APPLICATION NO.	FILING DATE	FIRST NAMED INVENTOR	ATTORNEY DOCKET NO.	CONFIRMATION NO.
09/616,638	07/26/2000	Percy Bennwik	10806-109	8709

Office Action Summary

DETAILED ACTION

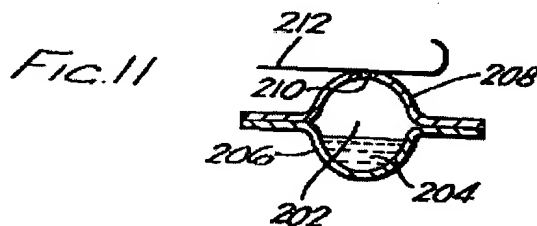
Regarding claim 1, Scherer teaches a pressurisable container for storing and ejecting liquid (204), the container comprising a front wall (208) having or surrounding a cavity (202) corresponding to the form of an open vessel, an opening (210) in the front wall (208) adapted of ejection of the liquid (204) from the container, said opening (210) defining a container axis, optionally a sealing (212) over the opening (210) adapted for temporary use, and a rear wall (206) closing and sealing the open part of the front wall (208) vessel to confine a space for the liquid (204) in the container, the rear wall (206) running at least partially perpendicular to the container axis and being displaceable or deformable for movement towards the opening to pressurize the container liquid (204), wherein the front wall (208) is substantially rigid in relation to the rear wall (206), the rear wall (206) before pressurizing the container is substantially flat or substantially single curved, and the rear wall (206) is deformable under stretching to substantially fill out the container cavity (202)(see Fig. 11, below).

Regarding claim 2, see Fig. 11, above.

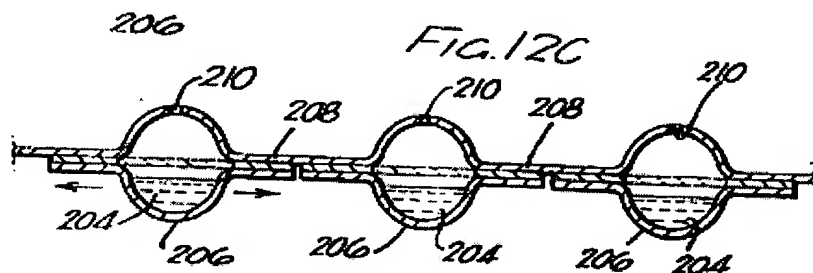
Regarding claims 14-17, see Fig. 12C, below.

Regarding claim 20, 21, 24 and 28, see Fig. 12C, above.

Regarding claim 40, Scherer teaches a rear wall (206) attached to the rear surface of a front wall (208)(see Fig. 12 C, above).

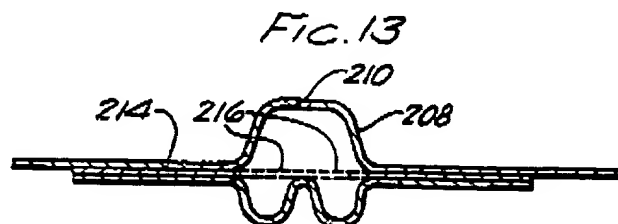
Regarding claim 27, see Fig. 13, below.

Regarding claim 92, Scherer teaches device comprising a ram (see Fig. 13).

**FIG. 3****FIG. 4**

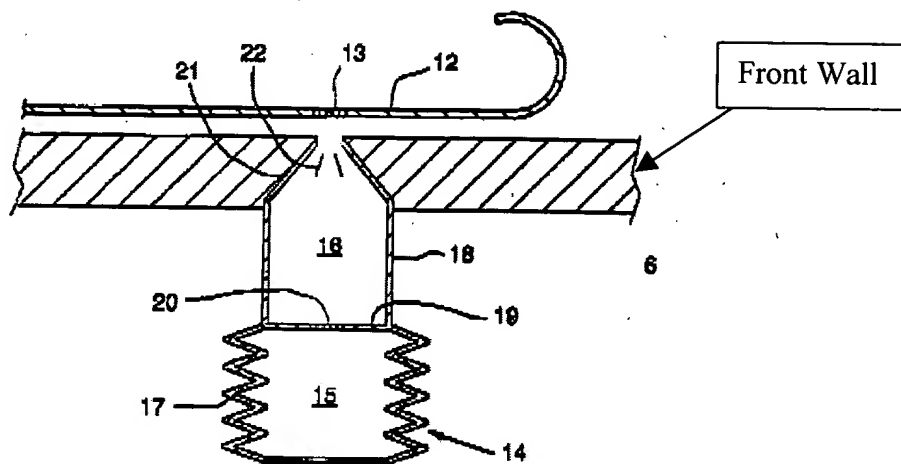
Lloyd *et al.* teach a pressurisable container (16) for storing and ejecting liquid, the container (16) comprising a front wall having or surrounding a cavity corresponding to the form of an open vessel, an opening (13) in the front wall (208) adapted of ejection of the liquid from the container, said opening (13) defining a container axis, optionally a sealing (12) over the opening (13) adapted for temporary use, and a rear wall (14) closing and sealing the open part of the front wall vessel to confine a space for the liquid in the container (16), the rear wall (14) running at least partially perpendicular to the container axis and being displaceable or deformable for movement towards the opening (13) to pressurize the container liquid, wherein the front wall is substantially rigid in relation to the rear wall (14), the rear wall (14) before pressurizing the container is substantially flat or substantially single curved, and the rear wall (14) is deformable under stretching to substantially fill out the container cavity, wherein the front wall has a thickness that increases away from the axis (see Fig. 3, below).

Regarding claim 21, see Fig. 3, below.

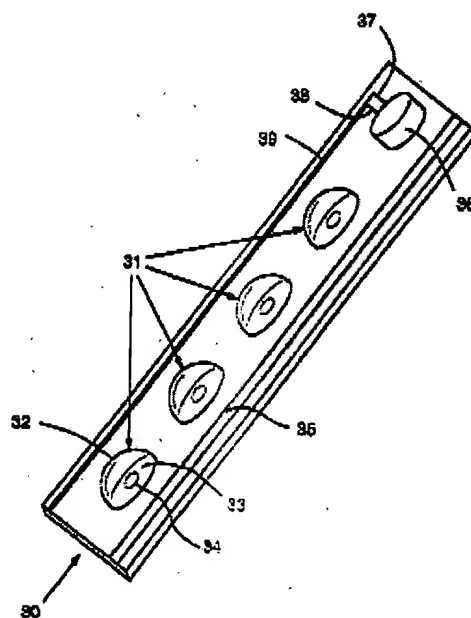
Regarding claims 14, 18, 20 and 42, see Fig. 4, below.

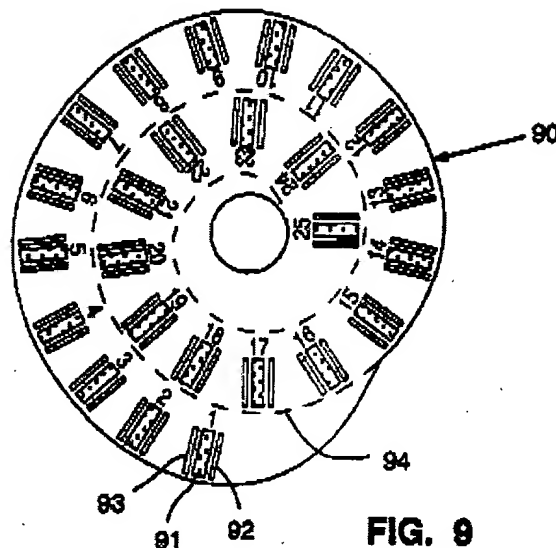
Regarding claims 22 and 23, see Fig. 9, below.

Regarding claims 24 and 25, Lloyd *et al.* teach a front wall (90) comprising a partial cylinder (e.g., the end portion of a cylinder)(see Fig. 9, below).

Regarding claim 26, Lloyd et al. teach several containers (91) positioned over two dimensions of the cylinder surface (see Fig. 9, below).

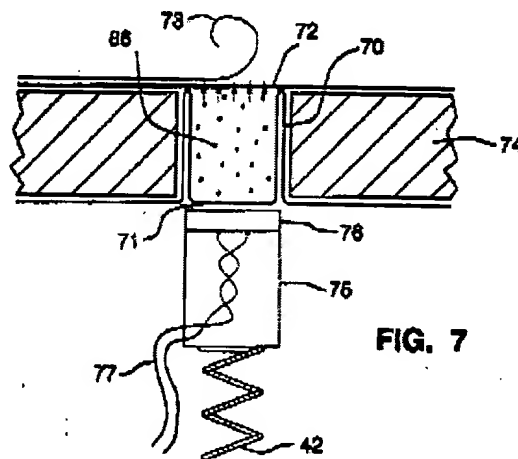
Regarding claims 64-68, Lloyd teaches an actuator (77), a ram (44) and a seat (41), into which containers may be fed and removed to be replaced by a subsequent container.

Regarding claim 75, see Fig. 7, below.

Regarding claims 77 and 78, see Fig. 7.
